# SERVICE BULLETIN

TITLE: Protection of Wiring Harness

BULLETIN NO. 248-A

Models Affected: 108-1 through 108-2394

Figure 1

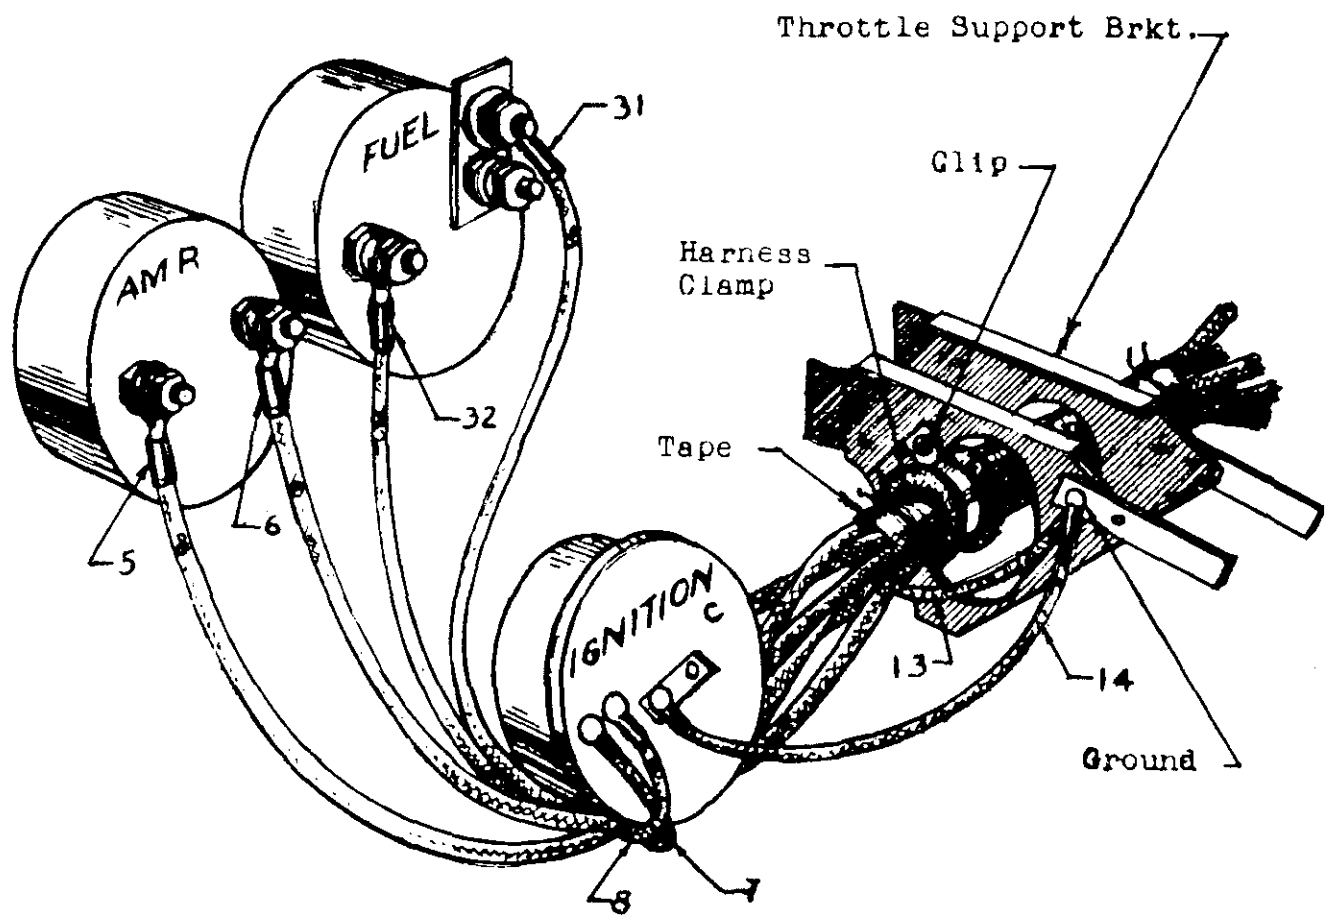
As a precautionary measure we recommend that airplanes within the above serial numbers be examined for possible chafing of the wiring harness at the throttle bracket behind the instrument panel. Should such a condition exist, the following corrective procedure is suggested:

Pull wires to left of panel and wrap into a bundle, using coreprene tape where the wires pass the throttle bracket. Taped area should be about ten inches long. Tie each end of the wrapped area with lacing cord to prevent any possibility of unwinding after performing this correction work.

Thread the wrapped wires underneath the carburetor heat control and through the lightening hole in the throttle support bracket. Install clip and harness clamp as shown in the illustration on the reverse side of this page. Secure the wrapped wires in the harness clamp.
